Re: 2024/0012/P 194 Goldhurst Terrace

This letter is in response to the two documents: “*Revised Proposed Floor Plans and North Elevation*”, uploaded by the developer on 18th October 2024, and the “*Neighbour Response Letter 28.10.2024 Issue*” submitted on behalf of the developer by Ms Olivia Frost of Savills.

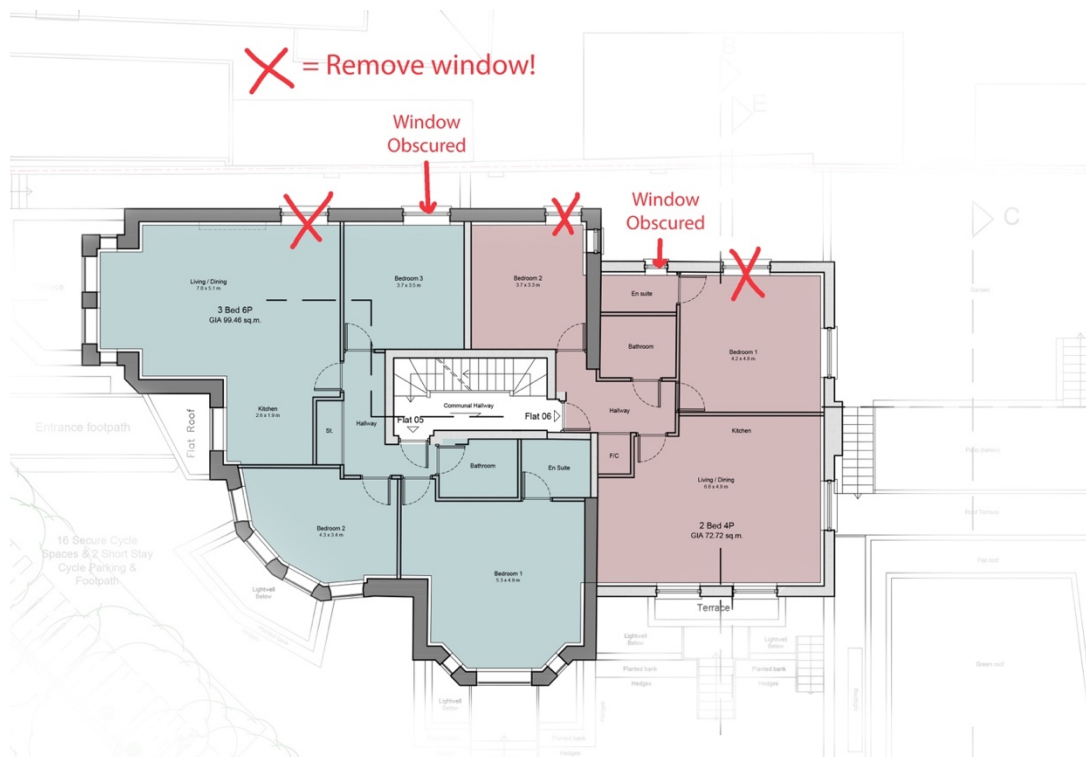
Regarding the former document, we were amazed to see that the new Northern elevation offers no significant improvement to the previous plan regarding overlooking. Worse, one extra window has been added!

The **existing** 194 building has **seven** windows located in the Northern elevation. None of them represent a significant problem of overlooking. But in the **new** plan, the **twenty** windows contemplated for the Northern elevation are almost all for habitable rooms with a view into our garden and several of our back rooms. As some sort of concession to amenity three of these windows are now labelled as “lower sash with obscure glazing”. But three half obscured windows are not a serious solution when there will still be another **17 unobscured overlooking windows.**

- 1) **Where rooms will have Western or Eastern facing windows, there is absolutely NO excuse for them to be permitted to have north facing windows as well.** This means eliminating the north facing windows from the living/dining rooms of flats 2, 5 and 7 and from bedrooms 1 and 2 of flats 4, 6 and 8.

- 2) **Obscured glass should be used for the entire window in ALL the en-suite bathrooms.**
- 3) **We understand that bedroom number 3 in flats 2, 5 and 7 needs a window, but this must be completely obscured glass.**

- 4) **The obscured glazing should be of a form that minimises light spillage from the building.**
- 5) ALL the windows on the Northern elevation should be permanently **fixed shut**, which is a standard requirement for planning approval with overlooking windows, intended both to avoid invasion of privacy, and also to reduce the risk of noise pollution. **Note that noise pollution is one of the chief concerns of the regulations designed to promote Amenity, as well as a crucial concern of our own family.** This neighbourhood is pleasant partly because it is very quiet. An increase in noise pollution would seriously impact the quality of life of ourselves and the neighbourhood, and should be avoided at all costs.
